City of Sanibel

Planning Commission

Planning Commission Meeting: June 23, 2026
Application Number: PL20260025 (Variance)
Applicant: Raychel A. Thomas, Esquire, Pavese Law Firm
Address: 5270 Indian Court

Planning Commission Meeting: June 23, 2026
Application Number: PL20260014 (Variance)
Applicant: Raychel A. Thomas, Esquire, Pavese Law Firm
Address: 2544 Harbour Lane

Attachment B - PL20260025
Survey with water depths

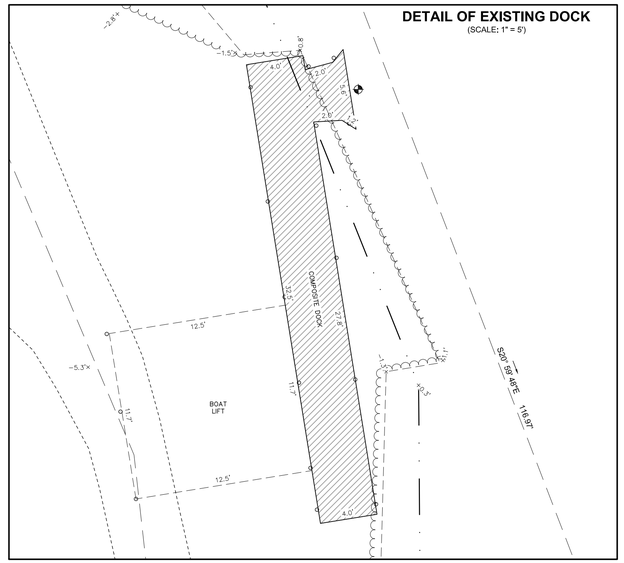
space between the -3' MLW line and the -4' MLW line for the proposed lifts to be located entirely within the -3' MLW area without extending past -4' MLW. Therefore, the applicant requests a variance from LDC §126-876 to allow the lifts to be partially located at a depth of less than -3' MLW as shown on the plans. The Applicant seeks a variance from LDC §126-875(1)(a) for the southern dock to angle approximately two feet, seven inches (2'-7") beyond 20% of the canal width to allow the southern boat lift to extend as far as it can into the -3' MLW depth without encroaching into the -4' MLW depth. The northern boat lift also extends slightly more than past 20% of the waterway, but remains within 15', of the mangrove root line present by this section of the dock, so a variance from the is not being requested, per LDC §126-875(1)(b).

Attachment C - PL20260025
Site Plan

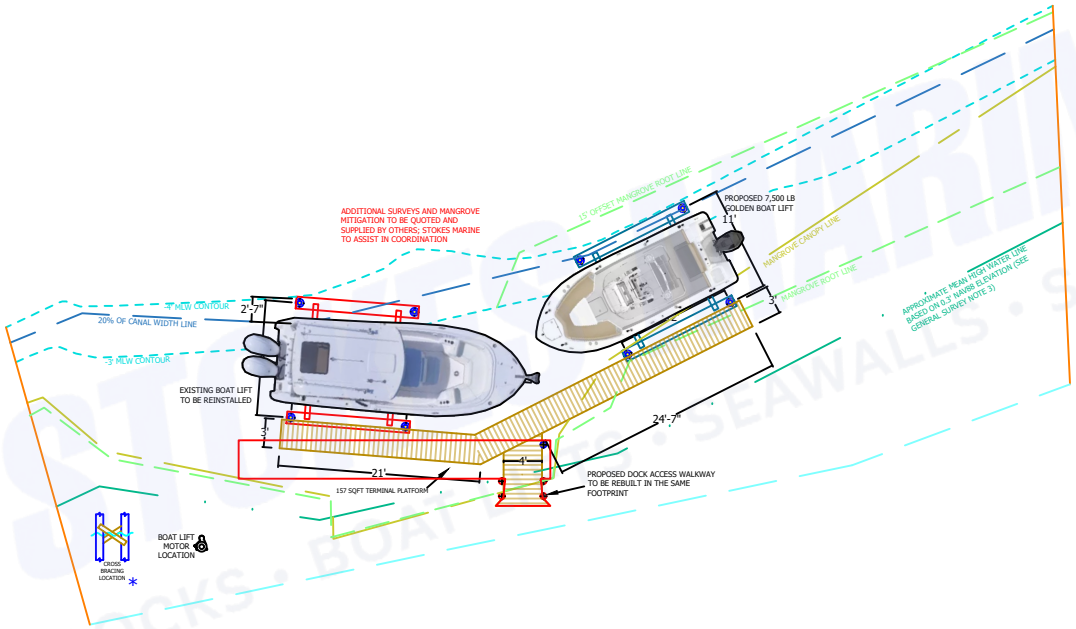
2. A Building Permit, Development Permit, and Vegetation Permit must be obtained for the construction of the dock and two boat lifts which is consistent with the proposed site plan (Attachment C).

Figure 2: Proposed dock location relative to docks on adjacent parcels

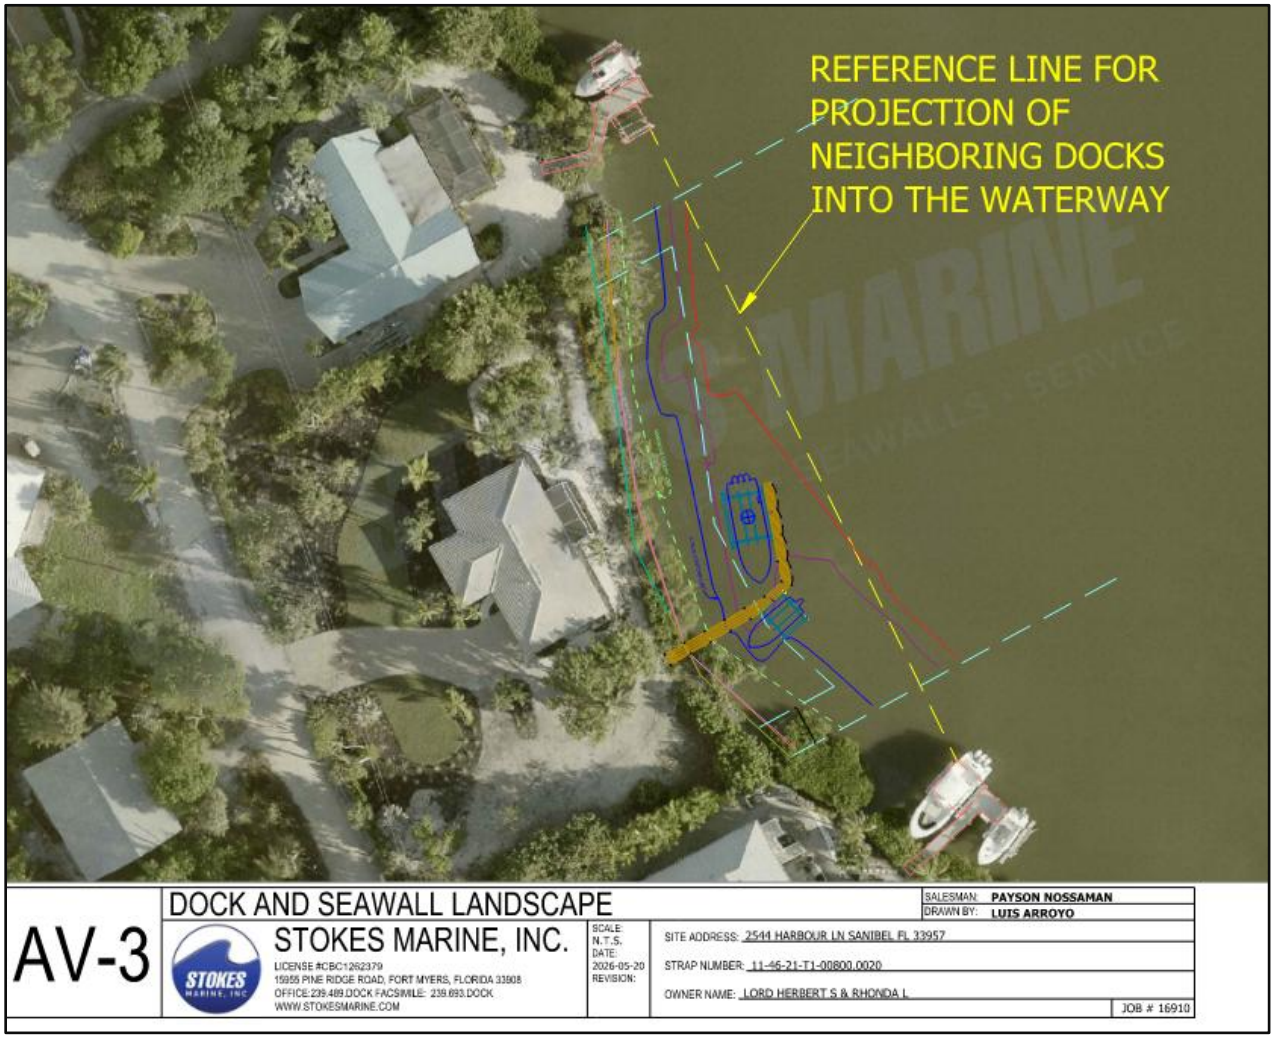
Staff Analysis: The proposed dock extends approximately 53-feet from the mean high water line. Applying the 1.5-foot setback for each 1-foot of waterward projection would require a 79.5-foot setback from each side property line. A straight line measurement of the lot corner to lot corner along the

waterway is approximately 185 linear feet making strict compliance with this standard impossible. The applicant is proposing a 36-foot 5-inch side setback from the south property line and an approximately 92-foot setback from the north property line.
